MEMORANDUM

From:	Tina Cuss Ecology Officer		
Service	WBC Ecology	App No:	253011
Address:	Billingbear Lodge, Maidenhead Road, Binfield, Wokingham, RG40 5RU.		
Proposal:	Householder application for the proposed erection of extensions and alterations to the dwelling, including changes to the ground floor and first floor layout, alterations to the roof form, and associated changes to fenestration, following the demolition and removal of the existing rear projection and associated structures as shown on the approved plans.		
Type of Development:	Other Householder		
Site Visit Made:	No

Figure 1: Emergence Summary

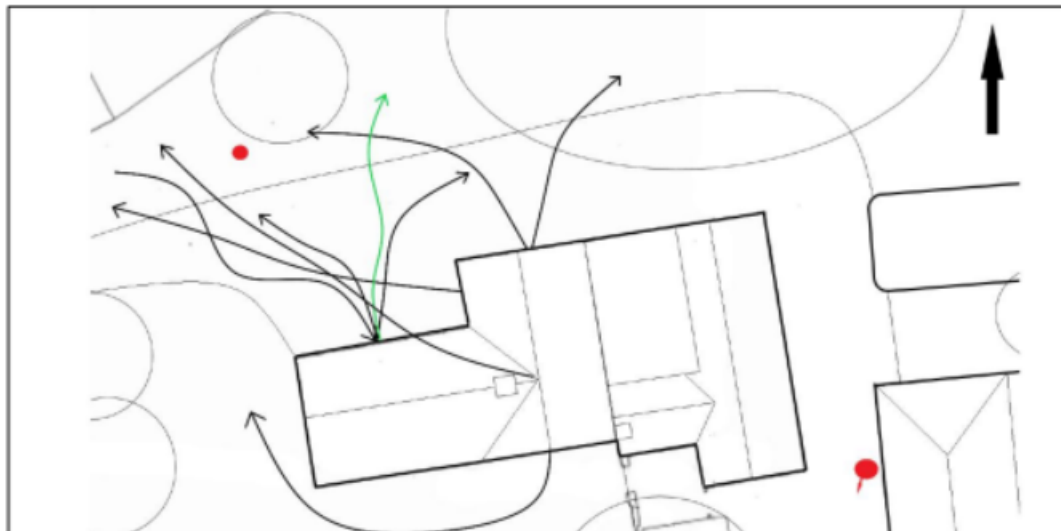
4 Acre concluded that there was a moderate, low and high levels of bat activity during the respective emergence surveys. During the 28 August 722 registrations were recorded by five surveyors equating to 1.60 per minute per surveyor.

I am satisfied that the survey effort and methodology are adequate for 4 Acre's Ecologist to conclude that there are at Common pipistrelle and Brown long-eared bat roosts in the main house and no roosts in the outbuilding surveyed. I agree that to carry out the proposed work legally the Owner requires a European protected species licence to be issued by Natural England.
